V2500-A1/A5 SERIES PROPULSION SYSTEM SERVICE BULLETIN

This document transmits Revision 2 to Service Bulletin EV2500-72-0503 and Revision 2 to the Supplement

V2500-ENG-72-0503

ENGINE – LP COMPRESSOR – INTRODUCTION OF NEW BRACKET FOR MODIFIED FB FLANGE OF FAN
CASE ASSEMBLY

Rework details and related parts
Figure 1

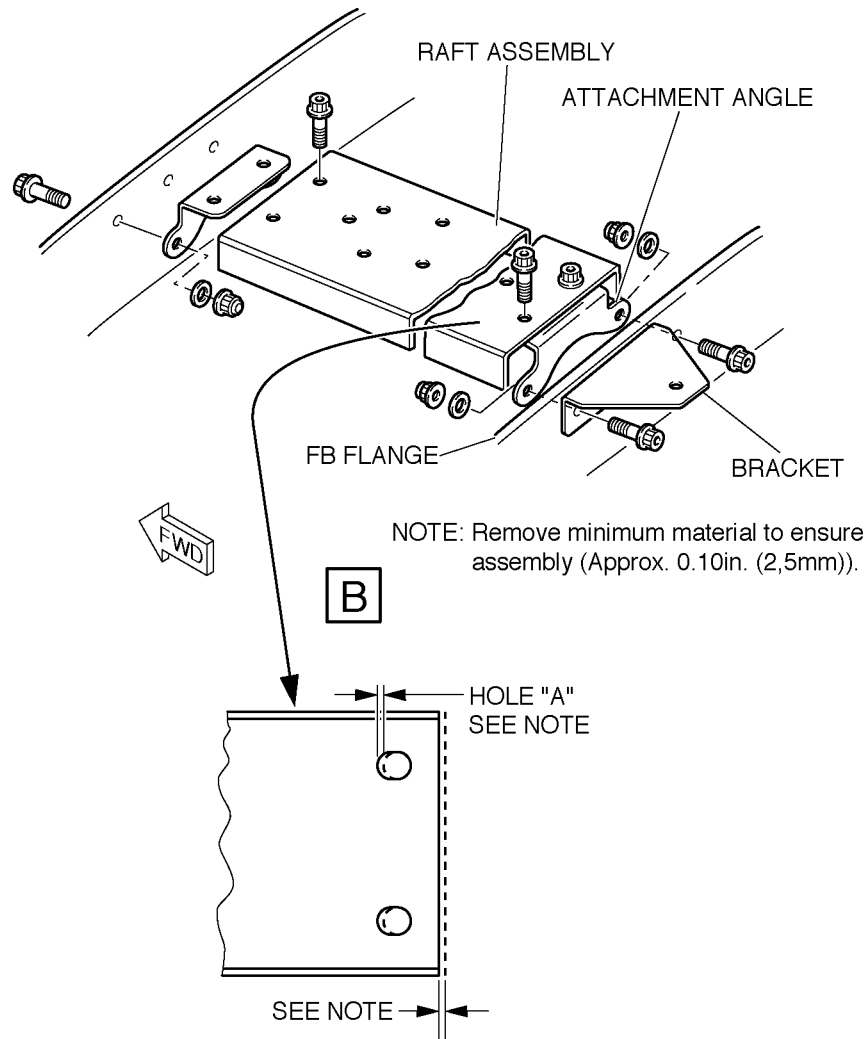
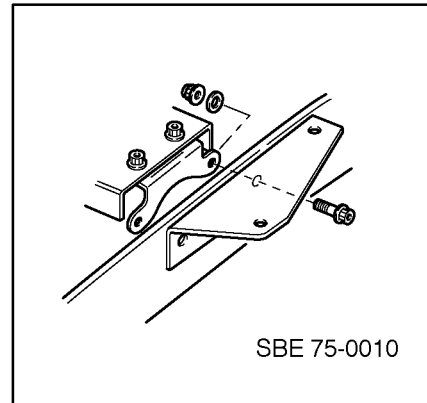
A. Prepare the raft assembly and damaged area of the FB flange on the fan case, refer to Figure 1 and 2.

- (1) Remove the clipping point 1103 and 0909 and tubes 117, 172, 202, 203, 206, 207 and 246 from the engine. Refer to the applicable Engine Manual (EM) Chapter/Section 72-00-32, Removal-03.
- (2) Remove the FCOC (Fuel Cooled Oil Cooler) from the engine. Refer to the applicable Engine Manual (EM) Chapter/Section 72-00-32, Removal-29.
- (3) Remove the raft assembly (71-51-43, 05-990), attachment angle (71-51-43, 05-870), and bracket (79-22-49, 13-900) from the FB flange. Refer to the applicable Engine Manual (EM) Chapter/Section 72-00-32, Removal-05.

Rework details for the raft assembly
Figure 2

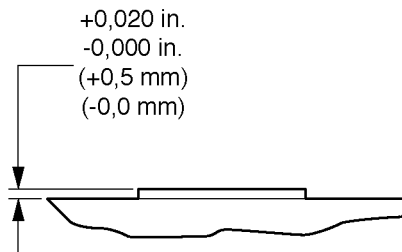
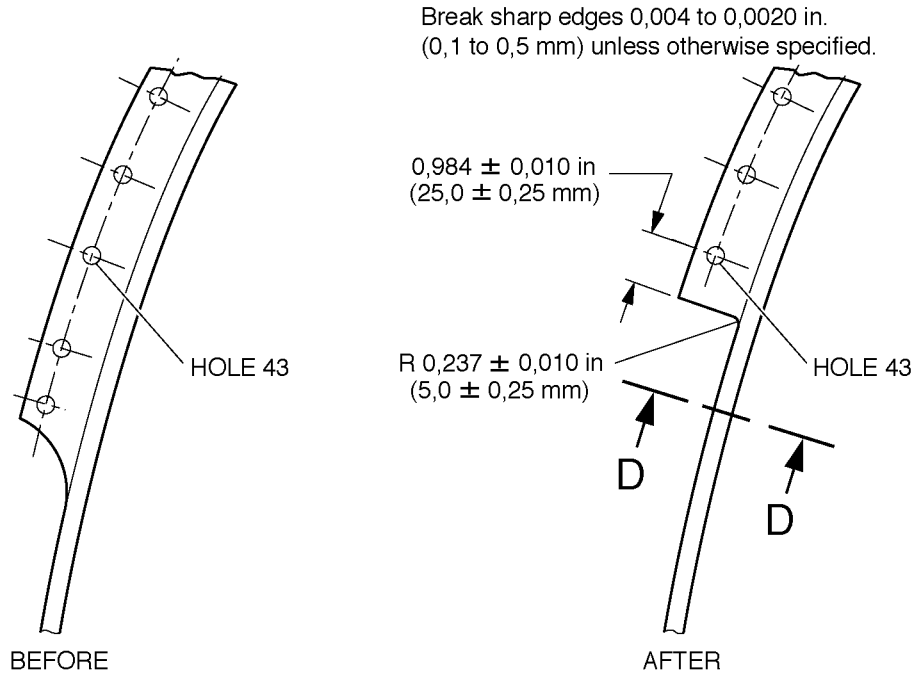
(i) The length of the raft assembly abutment side is decreased to ensure assembly, see Figure 2.

(ii) The holes of the raft assembly are elongated in the forward direction by a minimum amount to allow assembly, see Figure 2.

- (a) Enlarge hole 'A' 2 places in raft assembly. See Figure 2.
- (b) Remove the edge of the raft assembly in the FB flange side. See Figure 2.
- (c) Cancel existing part number and re-identify with new part number which is followed by the letters assy adjacent to existing part number.
 - (i) Use the vibro-peen method, refer to Figure 2 and SPM TASK 70-09-00-400-501.

Rework details for the FB flange
Figure 3

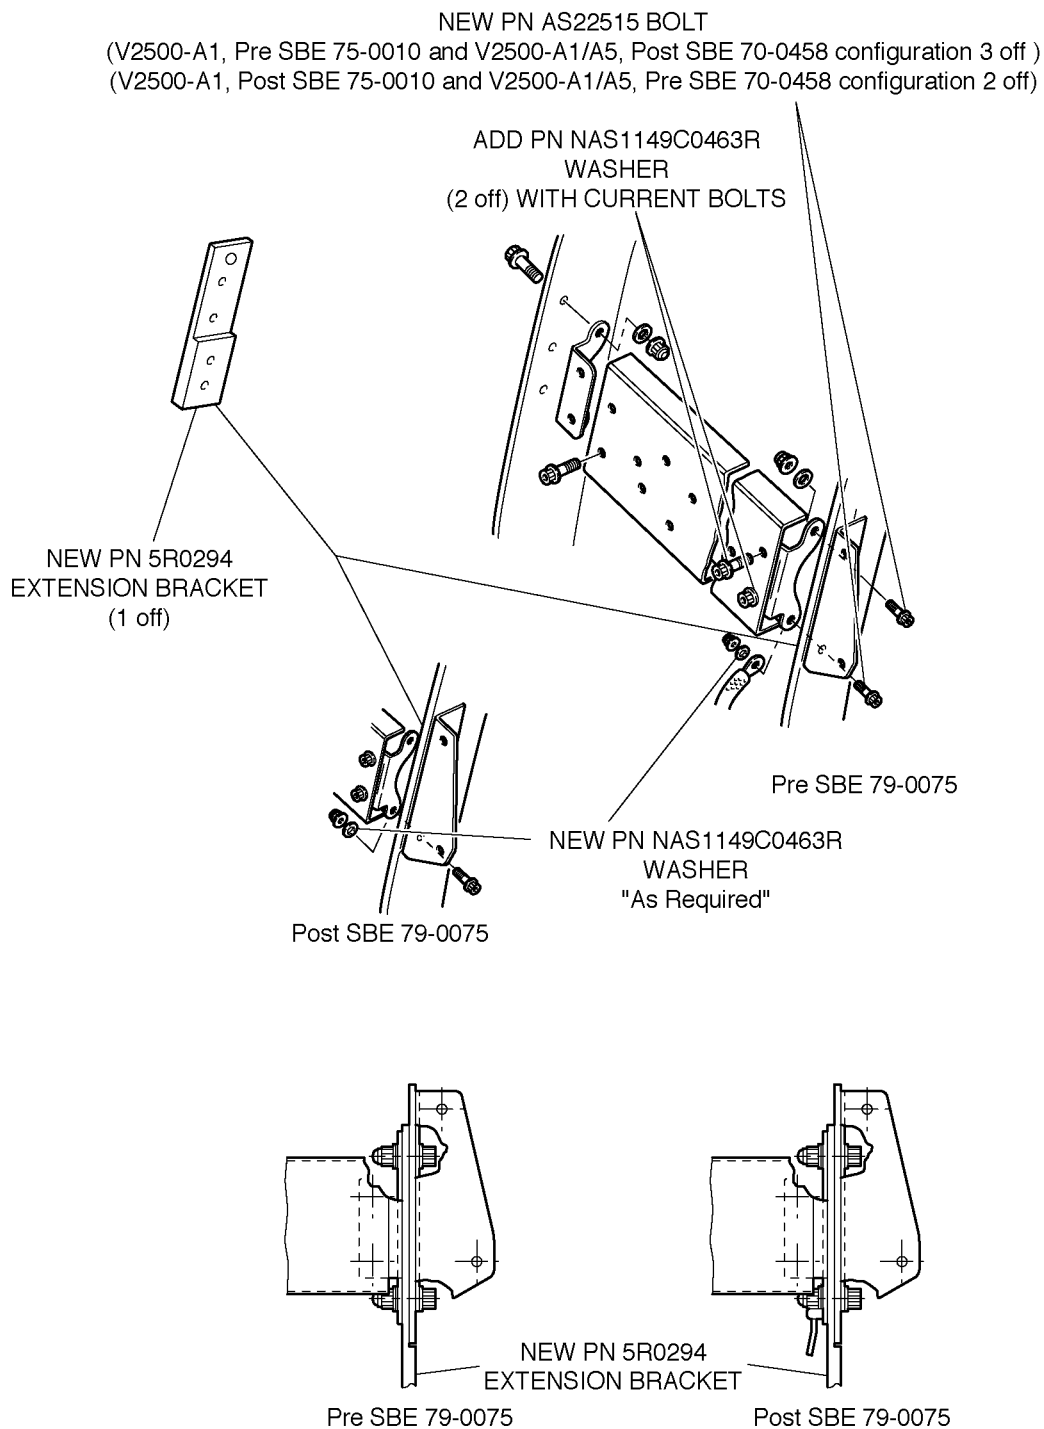
Reason for change
To revise Effectivity. To incorporate assembly instruction and part number of Pre-SBE 75-0010 when this SB is introduced. Fig.3 revised.
To revise Effectivity. To incorporate assembly instruction and part number of Pre-SBE 75-0010 when this SB is introduced. Fig.3 revised.

- (d) Modification of the existing fan case assembly is introduced, similar to the existing fan case assembly except for the length of the FB flange (FCOC top mount location) which is decreased to allow assembly of the extension bracket (P/N 5R0294), see Figure 3.

- (a) Clean the fan case assembly, refer to SPM TASK 70-11-26-300-503.
- (b) Crack test on the damaged area, refer to Figure 3 and SPM TASK 70-23-05-230-501. Use CoMat 06-063 fluorescent penetrant or CoMat 06-064 fluorescent penetrant. Record all cracks.

(c) Remove the damaged flange material, refer to Figure 3.

(d) Crack test again, do step (3)(a) and (b). The blend area must satisfy dimension given in Figure 3. If necessary, do step (3)(c) again.

Assembly instructions
Figure 4

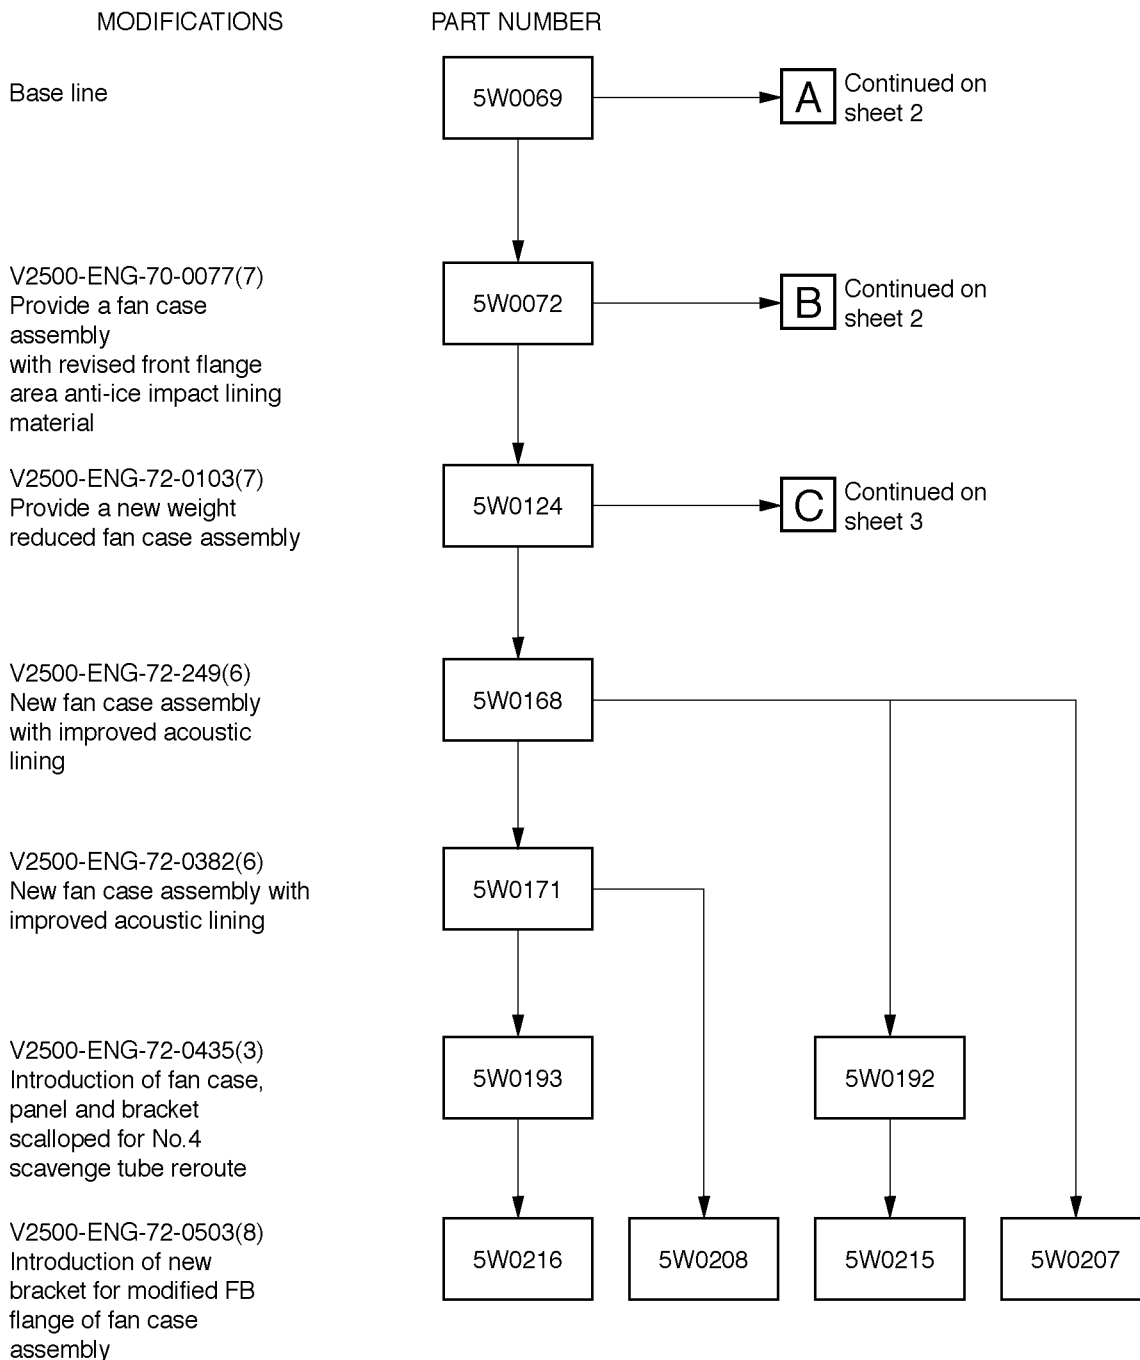
R Attach the attachment angle (71-51-43, 05-870) to the raft assembly with
R the two current bolts and new NAS1149C0463R washer (2 off), and then
R install the new 5R0294 extension bracket, raft assembly and bracket
R (79-22-49, 13-900) with new AS22515 bolt (3 off), NAS1149C0463R washer (as
R required) to the engine, refer to Figure 2 and 4. Refer to the applicable
Engine Manual (EM) Chapter/Section 72-00-32, Installation-01.

R Attach the attachment angle (71-51-43, 05-870) to the raft assembly with
R the two current bolts and new NAS1149C0463R washer (2 off), and then
R install the new 5R0294 extension bracket, raft assembly and bracket
R (79-22-49, 13-900) with new AS22515 bolt (2 off), NAS1149C0463R washer (as
R required) to the engine, refer to Figure 4. Refer to the applicable Engine
R Manual (EM) Chapter/Section 72-00-32, Installation-01.

Attach the attachment angle (71-51-43, 05-870) to the raft assembly with
the two current bolts and new NAS1149C0463R washer (2 off), and then
install the new 5R0294 extension bracket, raft assembly and bracket
(79-22-49, 13-900) with new AS22515 bolt (3 off), NAS1149C0463R washer (as
required) to the engine, refer to Figure 4. Refer to the applicable Engine
Manual (EM) Chapter/Section 72-00-32, Installation-01.
